OSHA Overhead Crane Inspections
Dated: 1983

1983 OSHA STRUCTURAL INSPECTION
OF THE
MAINTENANCE SHOP OVERHEAD CRANE
AND
SUPPORT SYSTEM
AT THE
COKE PLANT

1983 OSHA Structural Inspection
Maintenance Shop Overhead Crane & Support System
at the Coke Plant
April, 1983

CRANE RUNWAY
SUPPORT INSPECTION
CRANE: **EAST**
RUNWAY SYSTEM
DATE: _____ PAGE No. _____

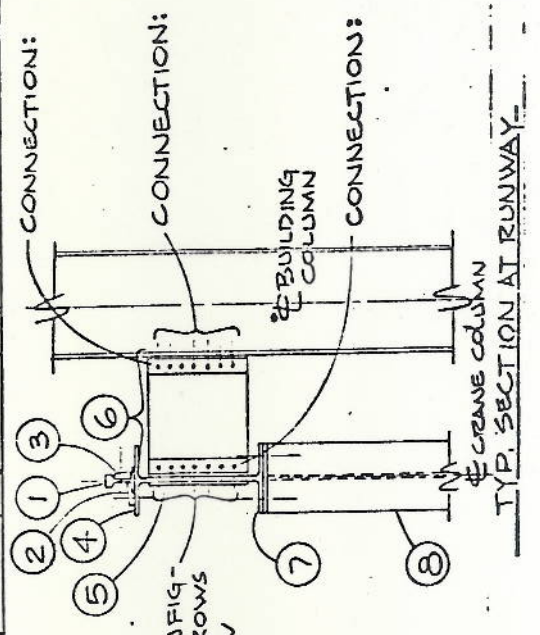
①	②	③	④	⑤	⑥	⑦	⑧	CRANE COLUMN FOUNDATION	REPAIR REQ'D
SOUTH To NORTH	CRANE RAIL	RAIL CLIPS	RAIL SPLICE BAR BOLTS	CRANE GIRDER	GIRDER SPICE	GIRDER TO COL. DIAPHRAGM	GIRDER TO CRANE COL. SEAT CONNECTION	CRANE COLUMN	CRANE COLUMN FOUNDATION	REPAIR REQ'D
col. 1		2L RI								
col. 2		3L RI								
col. 3										
col. 4		3L RI								
col. 5										
col. 6		3L RI								
col. 7										
col. 8		4L RI								
col. 9		2L RI								
col. 10										
11

**NOTE: CRANE
GIRDERS AND
COLUMNS IN
Good Condition**

REPAIRS	REPAIRS REQ'D.	CONDITION	RECOMMENDED ACTION
R1		LOOSE BOLTS	TIGHTEN BOLTS
R2		MISSING OR SHEARED BOLTS & LOOSE, MISSING, OR SHEARED RIVETS	REPLACE WITH HIGH STRENGTH BOLTS
R3		MISSING OR SHEARED SPLICE BAR BOLTS	REPLACE WITH PROPERLY SIZED SPLICE BAR BOLTS

CRANE RUNWAY SUPPORT INSPECTION
CRANE: **WEST**
RUNWAY SYSTEM
DATE: _____ PAGE NO. _____

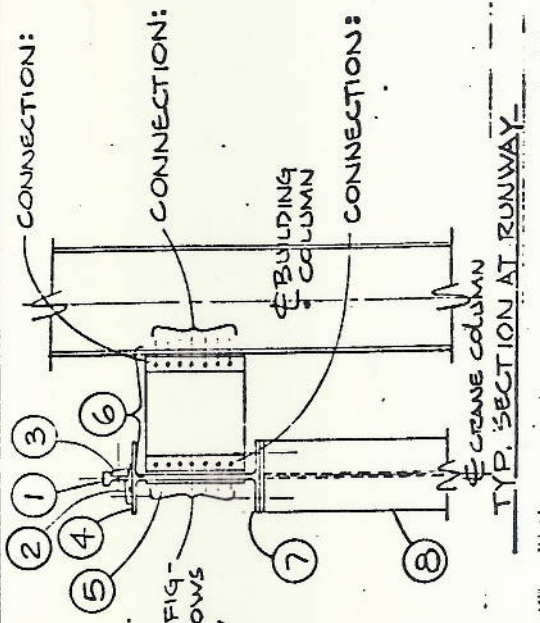
①	②	③	④	⑤	⑥	⑦	⑧	CRANE COLUMN FOUNDATION	CRANE COLUMN
	CRANE RAIL	RAIL CLIPS	RAIL SPICE BAR BOLTS	CRANE GIRDER	GIRDER SPICE	GIRDER TO COL. DIAPHRAGM	GIRDER TO CRANE COL. SEAT CONNECTION	CRANE COLUMN	CRANE COLUMN FOUNDATION	CRANE COLUMN
SOUTH To NORTH										
col. 1										
col. 2		2L								
col. 3			2L							
col. 4		4L								
col. 5		2L								
col. 6			2L							
col. 7		3L								
col. 8		2L								
col. 9		4L								
col. 10										
11

NOTE:
CRANE GIRDERS
And columns
IN Good
CONDITION.

REPAIRS REPAIRS REQD.	CONDITION	RECOMMENDED ACTION
R1	LOOSE BOLTS	TIGHTEN BOLTS
R2	MISSING OR SHEARED BOLTS & LOOSE, MISSING, OR SHEARED RIVETS	REPLACE WITH HI-STRENGTH BOLTS
R3	MISSING OR SHEARED SPICE BAR BOLTS	REPLACE WITH PROPERLY SIZED SPICE BAR BOLTS
